THE CHAMPION PAPER & FIBRE CO.
CANTON, N.C.
ENGINEERING DEPARTMENT

PROPOSED DRYER CHANGE FOR NO. 12 PAPER MACHINE

DATE OCT. 9, 1951
DRAWING NO. **BC-153-418-12**

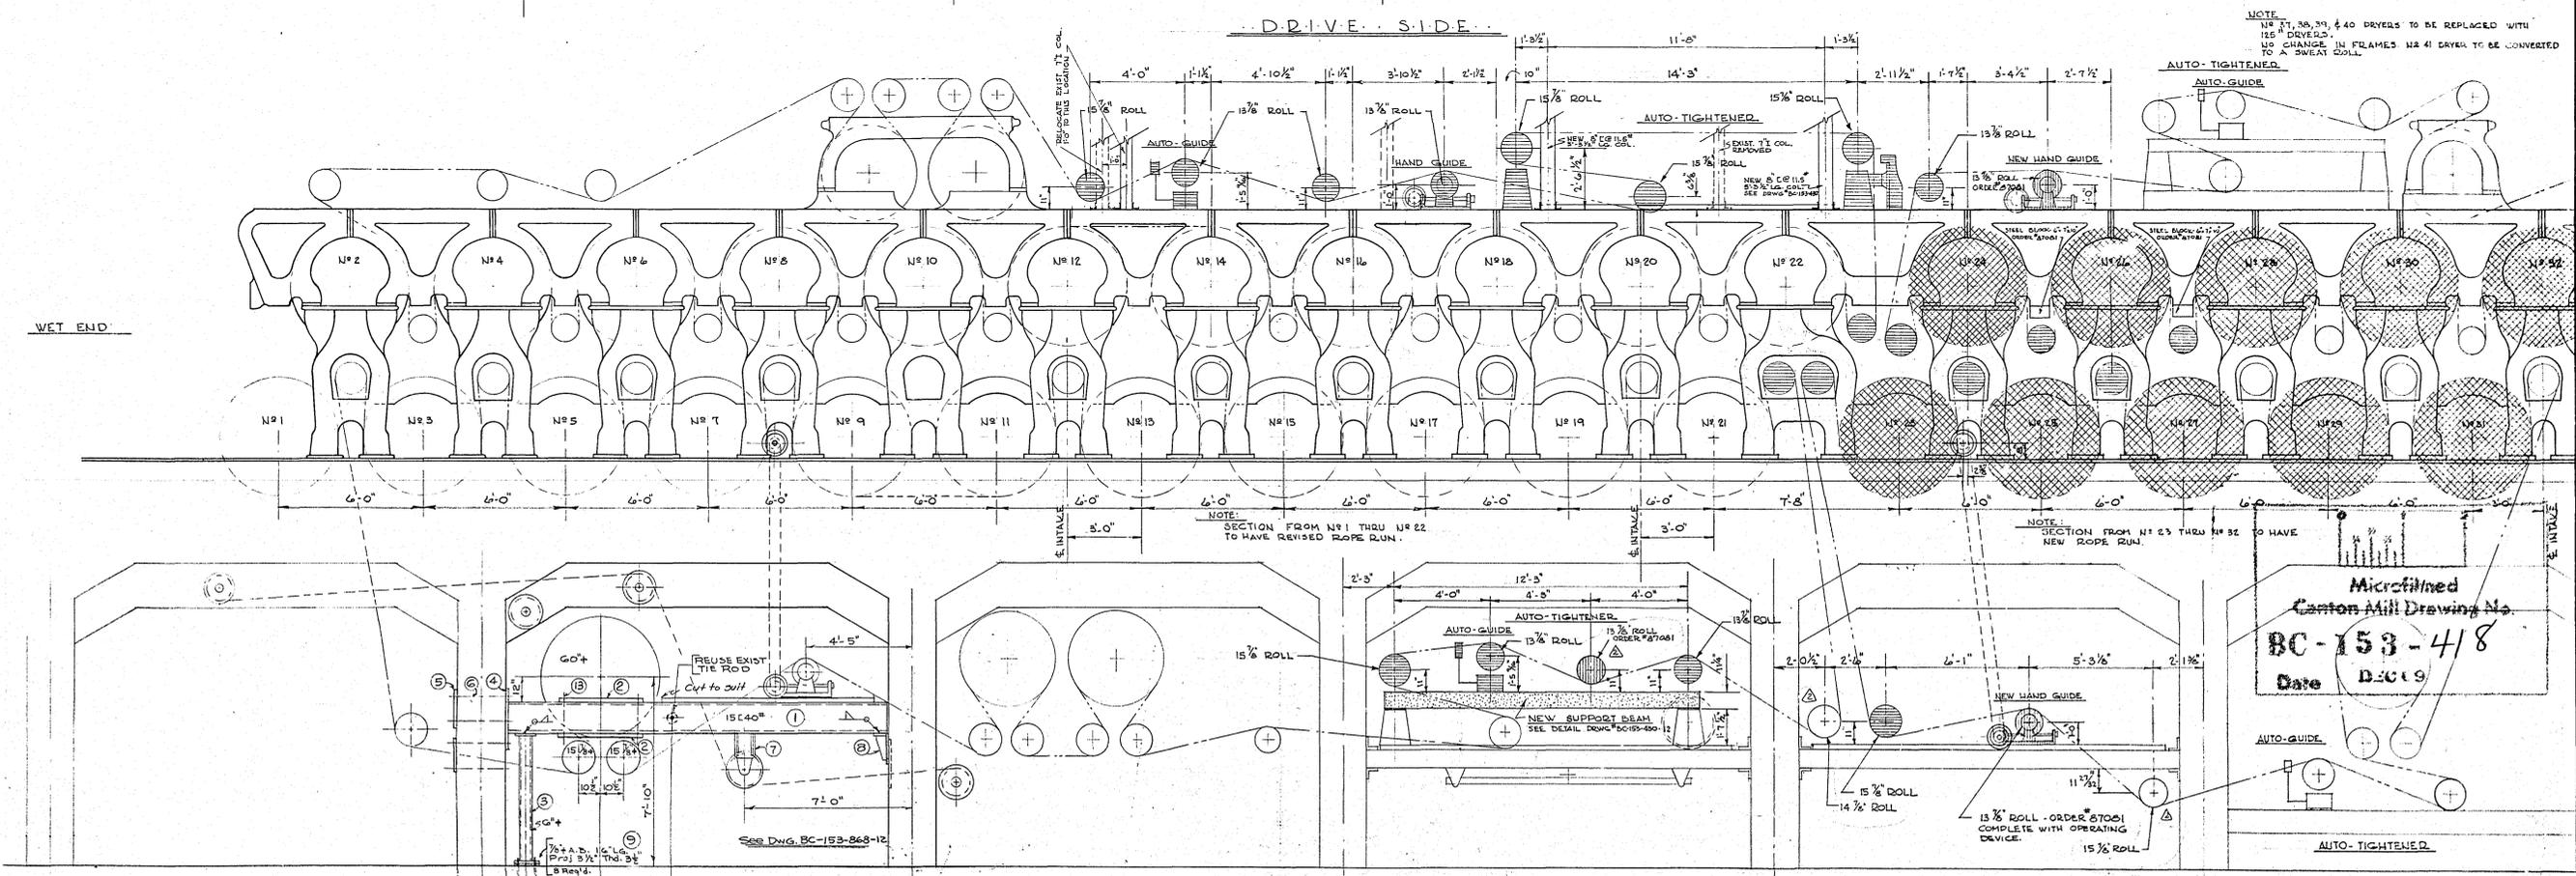
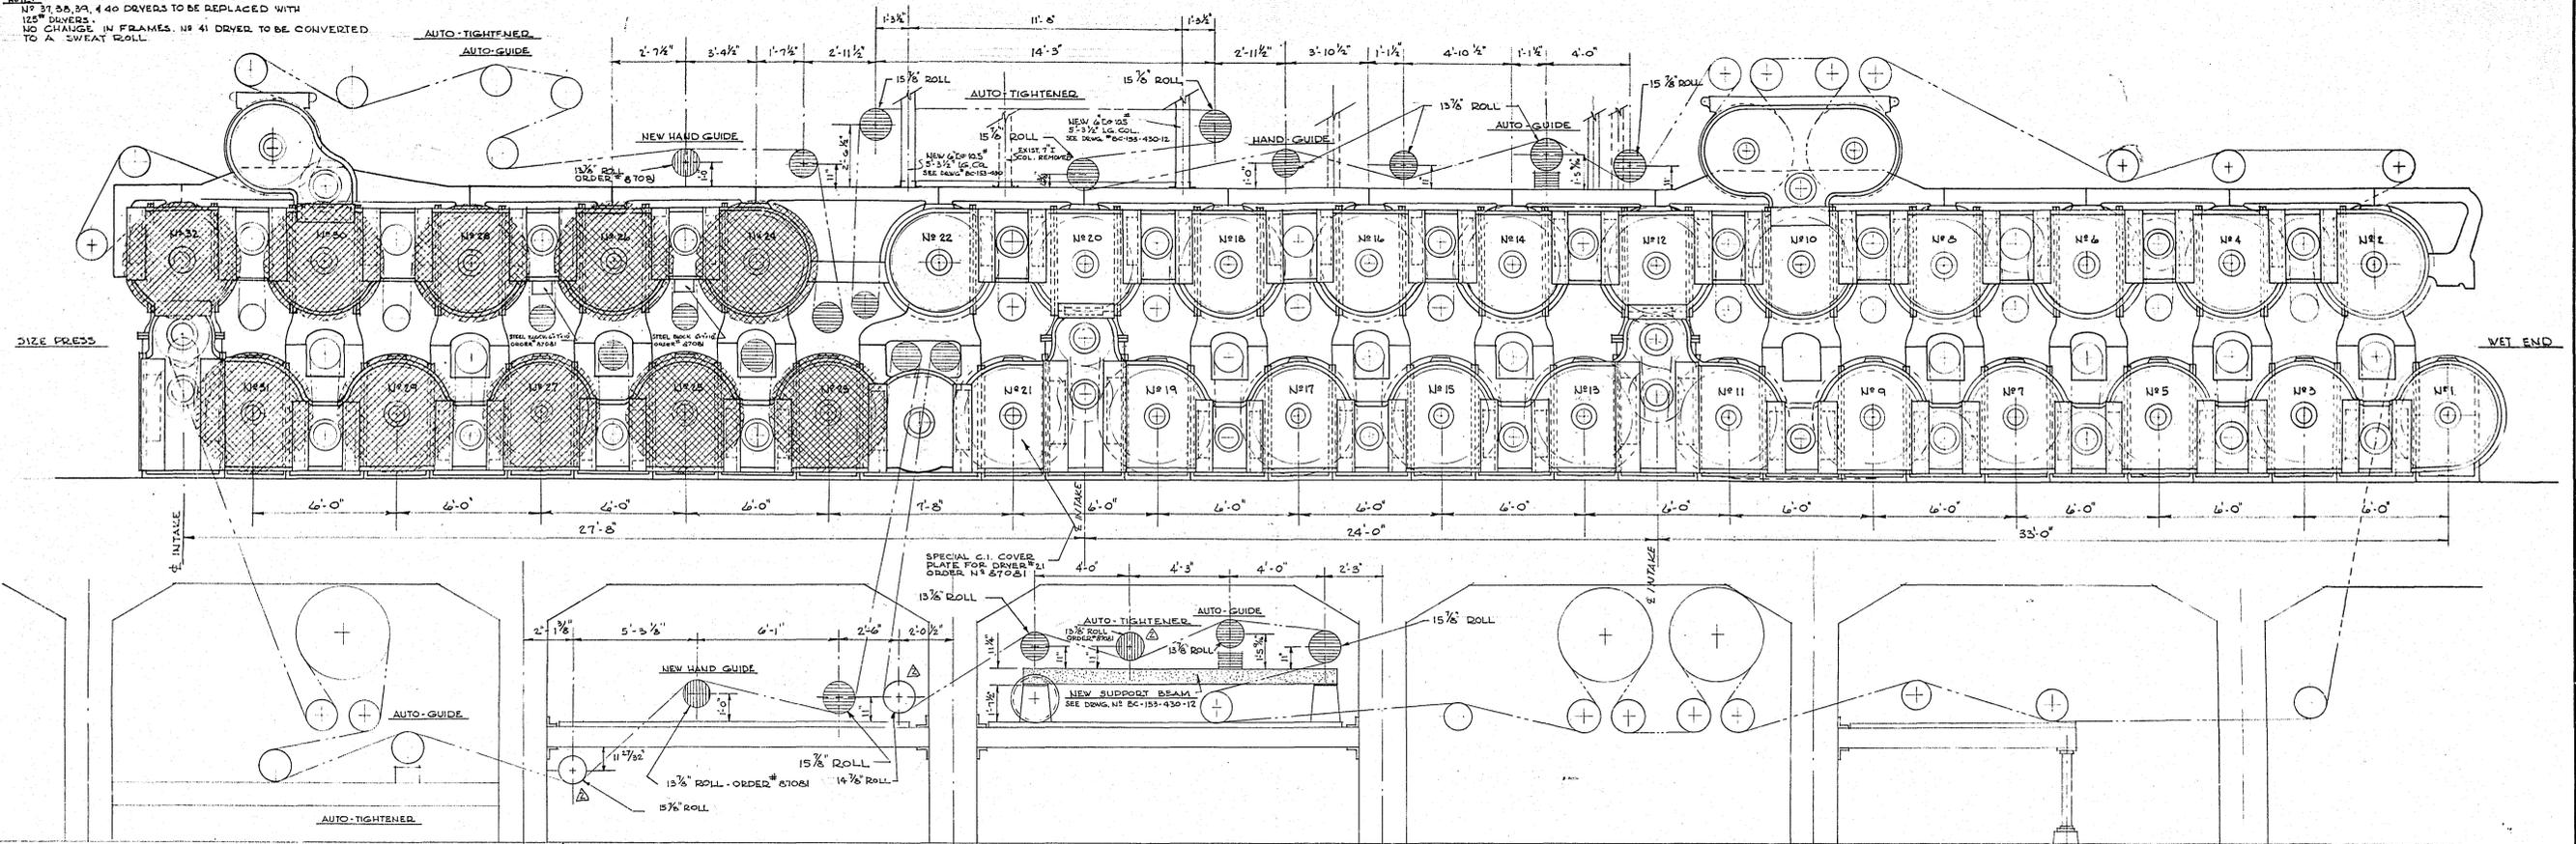
NOTE: NO. 31, 33, 39, 44 DRYERS TO BE REPLACED WITH 125" DRIVERS. NO CHANGE IN FRAMES. NO. 41 DRIVER TO BE CONVERTED TO A SWEAT ROLL.

NOTE: ALL NEW & RELOCATED FELT ROLLS ARE TO BE SET INTO POSITION PRIOR TO DRILLING OF FRAMES FOR ANCHOR BOLTS. RELOCATED DRIVER FRAMES TO BE SET IN POSITION PRIOR TO DRILLING & TAPPING OF SOLE PLATE.
